REVIEW OF BNE / NET CONE FOR T-4 AUCTION

Undertaken for the Electricity Association of
Ireland

15th June 2018

Figure 1 T-4 Auction: Demand Curve Options

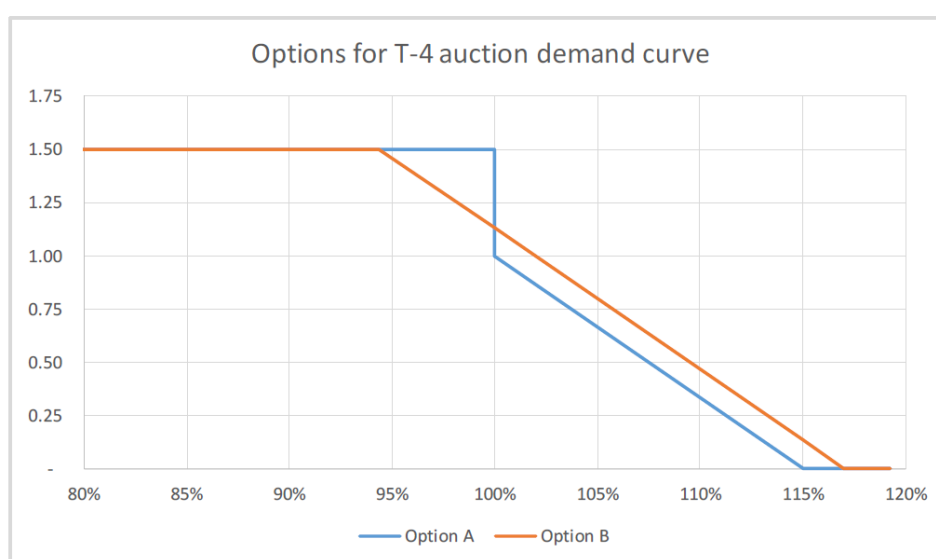
- 9.9 If the value of Net CONE employed to set the parameters for the T-4 auction is underestimated, then:
- In the case of Option A, at true net CONE there would be no change to the capacity procured; and
 - In the case of Option B, at true net CONE there would be less capacity procured and thus the system would be less secure.
- 9.10 Any over or under procurement of capacity could of course be adjusted in the subsequent auctions.
